Access Compliance Report

Public Rights-of-Way

(Curb Ramps)

Intersection ID: 28068	Main Street: BORCHETTA_DR	Cross Street: MITCHELL_GLEN_DR	Location: NW
ADA ID: 61A66F9EF1F6	Ramp Type: BlendTrans2	Initial Pass/Fail: Fail	Overall Compliance: No
		Severity Score: 25

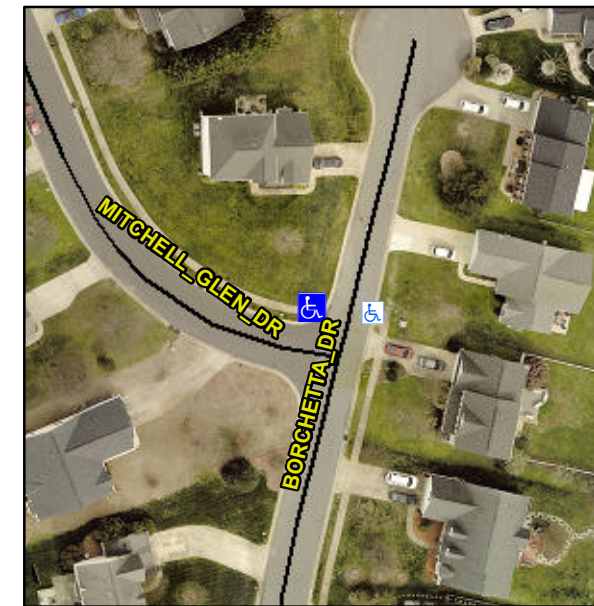
Not Found, R304.5.3

Compliance	Description	Data	Compliance	Description	Data
N/A	Ramp Length (in)	96.0	Yes	BlendTrans Slope (%)	2.2
Yes	Ramp Width (in)	48.0	No	BlendTrans XSlope (%)	9.2
N/A	Flare Type LT	N/A	N/A	Flare Type RT	N/A
N/A	Flare Slope LT (%)	N/A	N/A	Flare Slope RT (%)	N/A
N/A	Flare Traversable LT?	N/A	N/A	Flare Traversable RT?	N/A
N/A	Landing Length (in)	N/A	N/A	DWS Provided?	N/A
N/A	Landing Width (in)	N/A	N/A	DWS Contrast?	N/A
N/A	Landing Slope (%)	N/A	N/A	DWS Length (in)	N/A
N/A	Landing X Slope (%)	N/A	N/A	DWS Full Width?	N/A
N/A	Landing Curb? (Y/N)	N/A	N/A	DWS Offset (in)	N/A
N/A	Shared Landing?	N/A			
N/A	Gutter Ponding?	N/A	N/A	Gutter Slope (%)	N/A
N/A	Gutter Lip Ht (in)	N/A	N/A	Gutter X Slope (%)	N/A
N/A	Painted X Walk1?	No	N/A	Painted X Walk2?	No
	X Walk 1 Direction	To SW		X Walk 2 Direction	To E
	X Walk 1 Width (in)	N/A		X Walk 2 Width (in)	N/A
	X Walk 1 Slope (%)	2.6		X Walk 2 Slope (%)	4.1
	X Walk 1 X Slope (%)	4.3		X Walk 2 X Slope (%)	4.1

N/A	Ramp inside XWalk1?	N/A	N/A	Ramp inside XWalk2?	N/A
	Road Slope (%)	5.5		Clear Space?	N/A
	Road X Slope (%)	1.7	N/A	Clear Space to XWalk (in)	N/A
N/A	Any Obstructions?	N/A	N/A	Storm Grate/Utility Hazard?	N/A
	Obstruction Type			Storm Grate/Utility Type	
		N/A			N/A
			Yes	Surface Condition? (G/P)	Good
			No	Curb Slope (%)	6.6

Remove & Replace Curb Ramp With Two New Directional Ramps or Equivalent.
